## FOR PERCOLATION TESTING AND SITE EVALUATION

RE: PERCOLATION TEST RESULTS-A521637  
Tax Map 29, Parcel 24  
Lot 15, 11637 Masters Run Rd.

RE: Preliminary Percolation Test Results  
The Chase, Lot 15, Masters Run

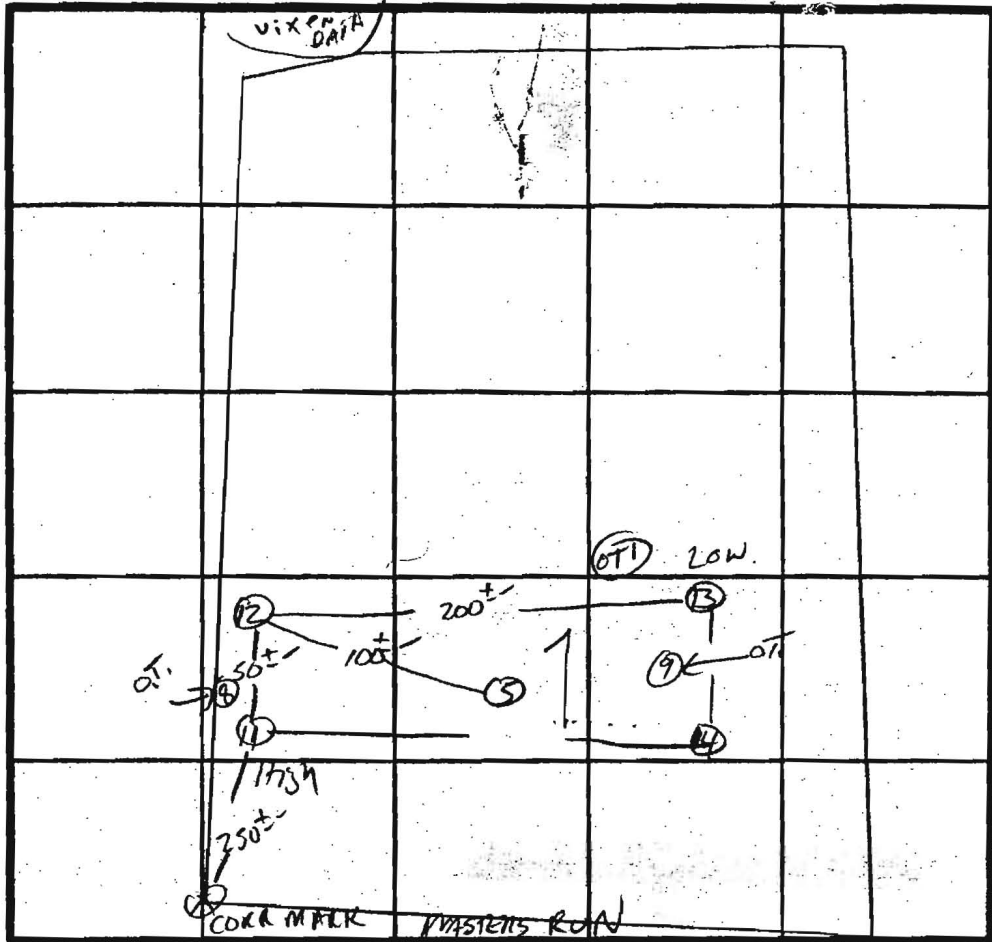
RE COMMEND  
 NO DOWNHILL ADJUSTMENT BEYOND HOLES ①-④

REMARKS ADJUSTMENT REM'D AWAY FROM SHARP SWALE AS SHOWN  
 SANITARIAN M. Rifkin BACKHOE McField OTHERS Greg Phillips, owner  
 TEST HOLES USED IN SDA ①-④ OK AVG. PERC TIME SQ. FT/BR  
 TRENCH WIDTH INLET DEPTH MAX. BOT DEPTH EFFECTIVE SAW

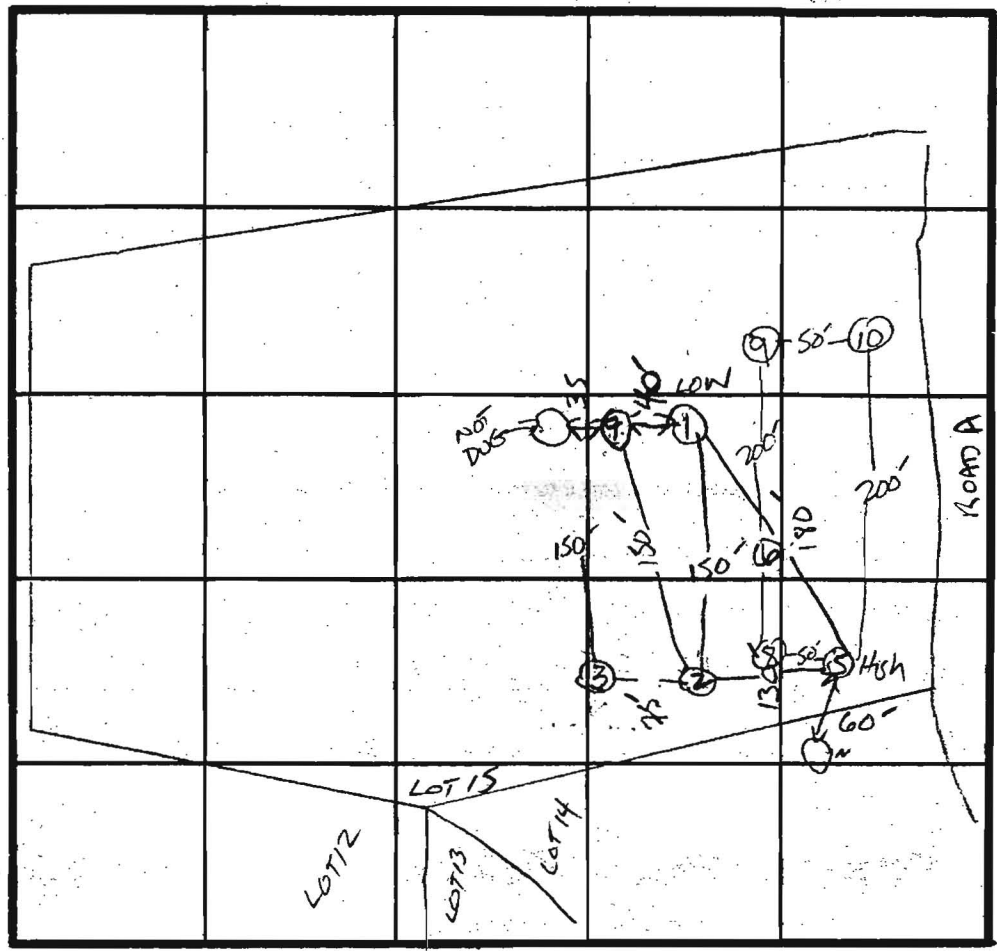
REMARKS HOLES DIFF FROM PLAN; SHALLOW SYSTEM ONLY
